SPECIAL CALLED PLANNING AND ZONING BOARD HEARING

CITY OF LAKE CITY

i. SPR22-15, a petition submitted by Jarod Stubbs, as agent for Daniel Hotte of GWC Development Partners, LLC, owner, for a site plan review application for a property located in a commercial highway interchange zoning district, parcels 35-3S-16-02524-001 and 35-3S-16-02524-102.

REVIEW REPORT TO PLANNING AND ZONING, BOARD OF ADJUSTMENT AND HISTORICAL COMMITTEES' BY STAFF FOR SITE PLAN REVIEW, SPECIAL EXCEPTIONS, VARIANCES, COMPREHENSIVE PLAN AMENDMENTS/ ZONING AND CERTIFICATE OF APPROPRIATENESS

C6.0

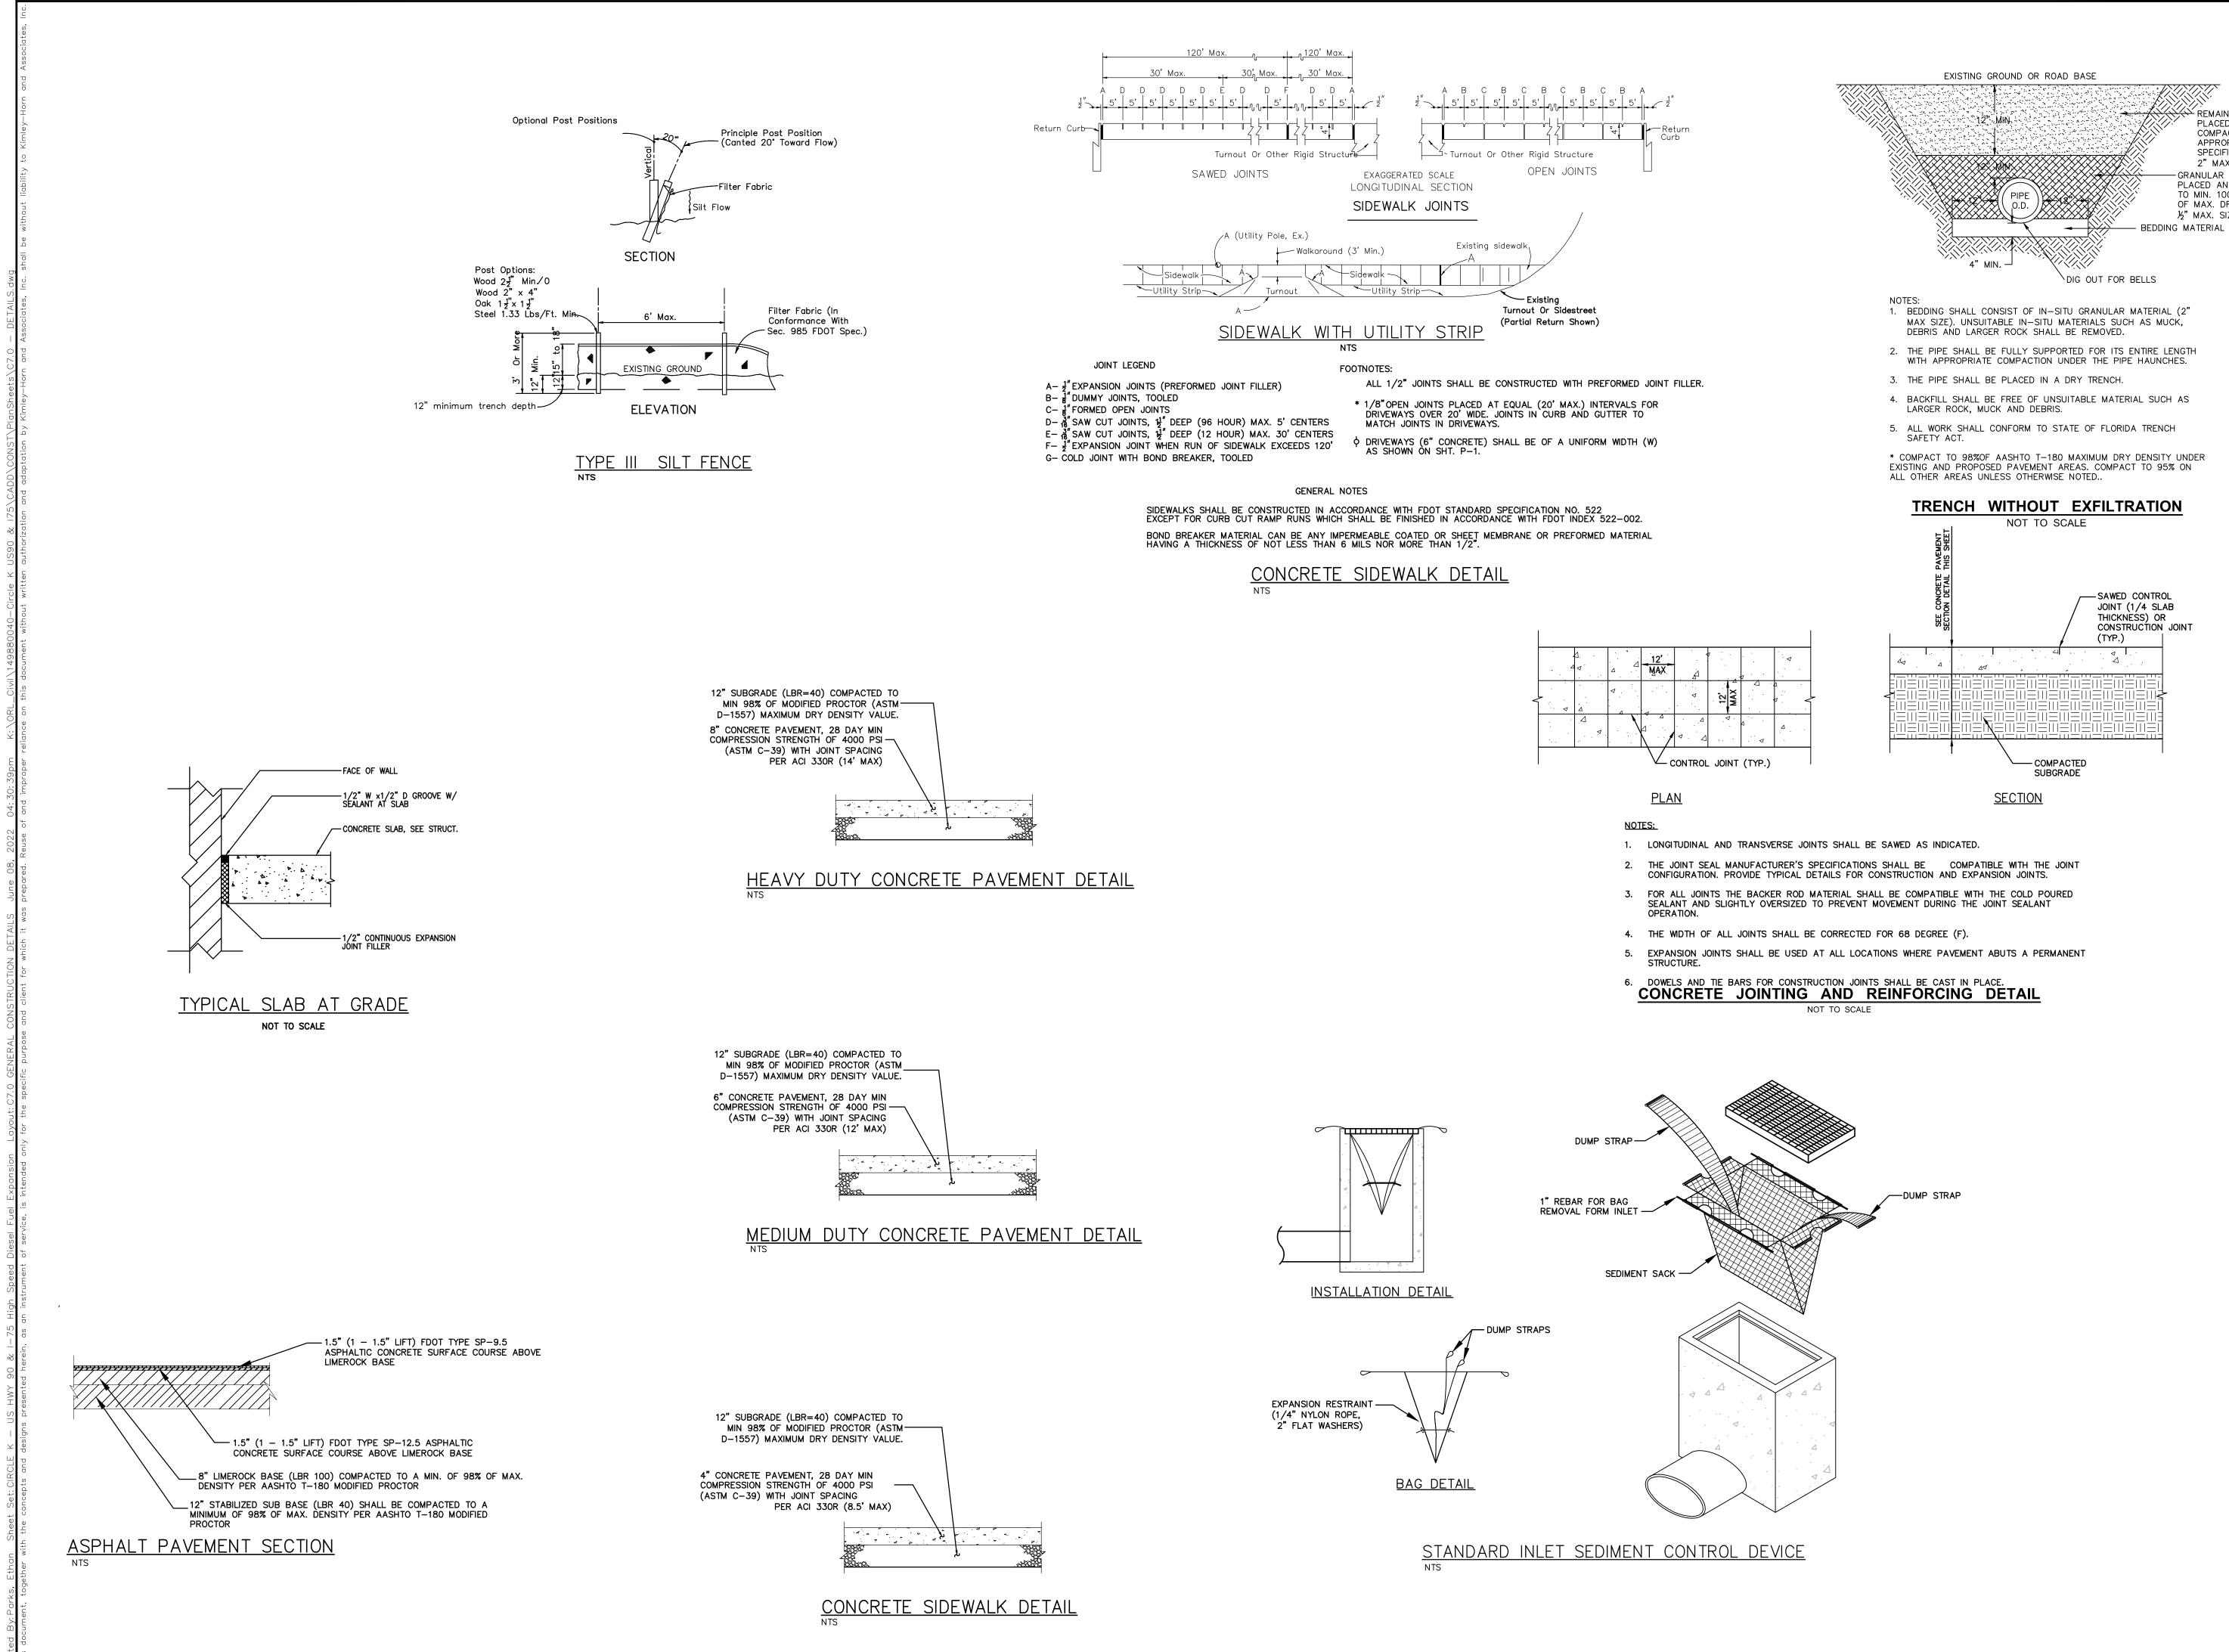
| Water Department: Approved Disapproved Reviewed by: |
|---|
| Utility Plan 6.0 dated 05/04/22 references a 1" water meter and an existing 6" sewer tap. A tap application would be required to access city utilities. |
